# Comment 86: 802.3aq LRM Draft 3.0

802.3aq LRM interim meeting

Phoenix January 12, 2006

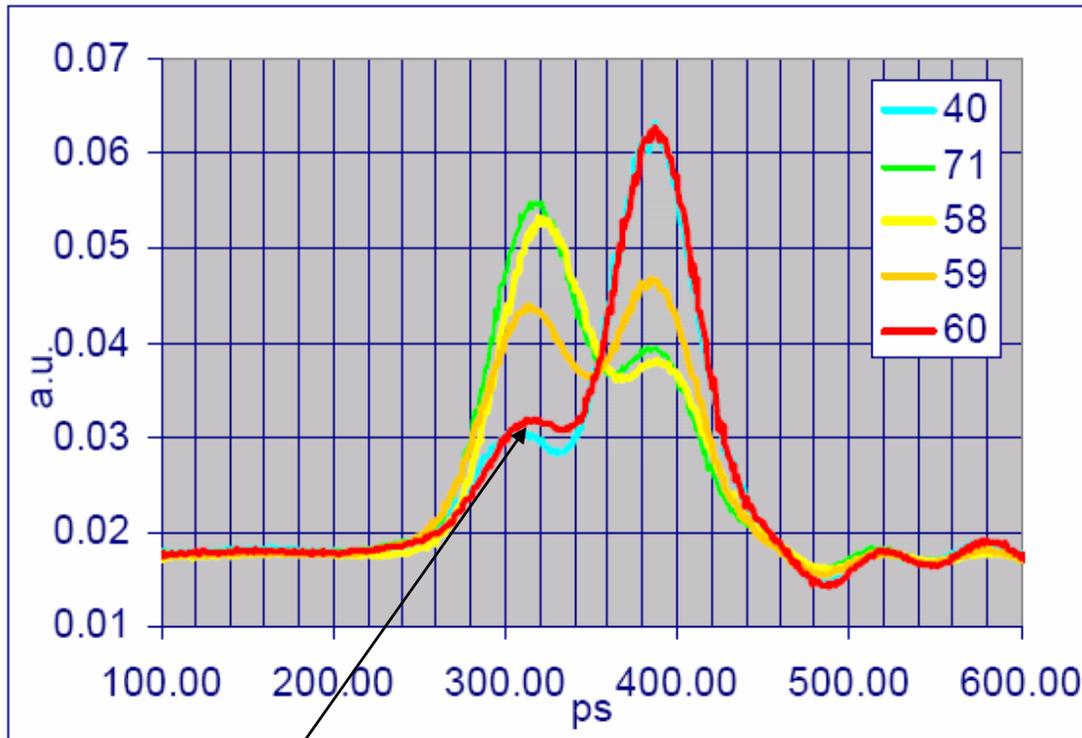
It is generally accepted that split pulses do occur at the center. The assertion here is that the modeling needs to better estimate the effect.

# Split pulse (king\_2\_1104.pdf)

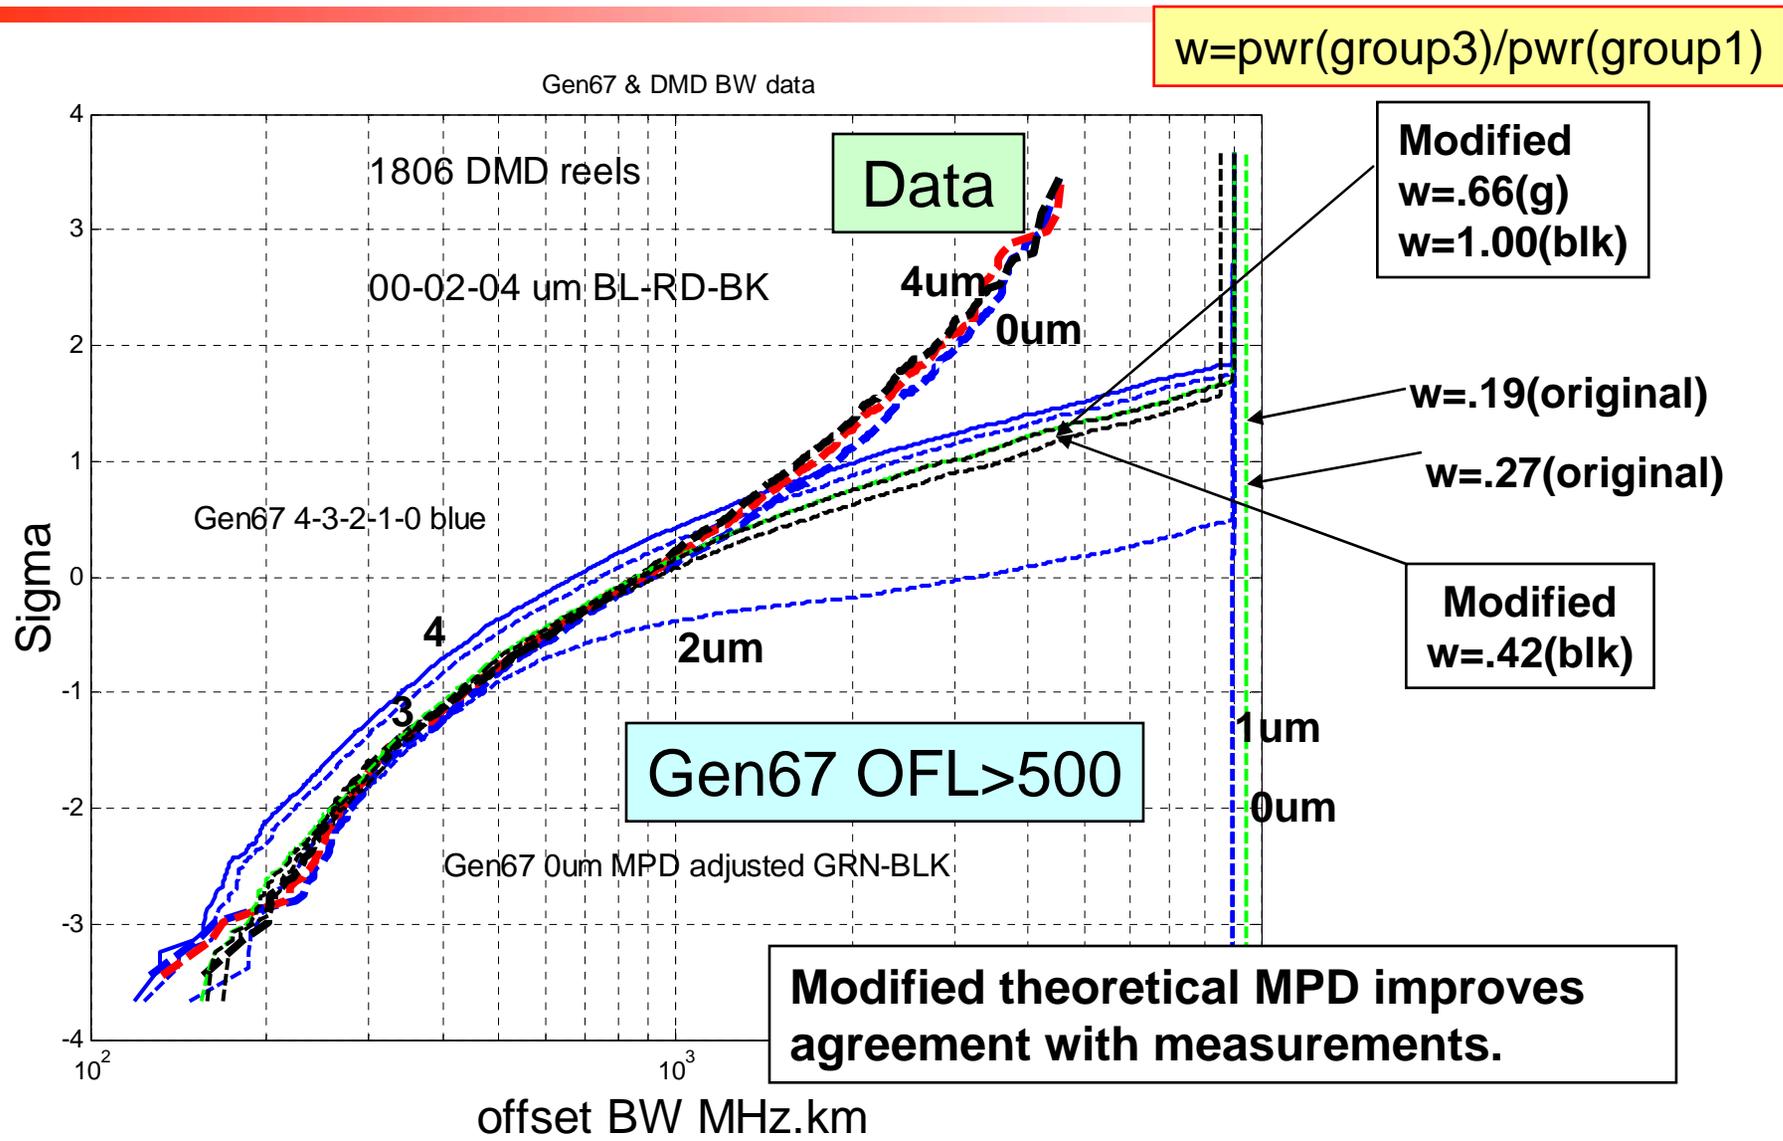
**Corning experience is that we don't see the "infinite bandwidth" with 0um-1um launch with fibers with pulse splitting which is noticeable with 4um offset.**

Recommendation is to use MPD in modeling which includes a split pulse ratio of  $\sim .40$  (.4 - .6 – 1.00 give about same EMB)
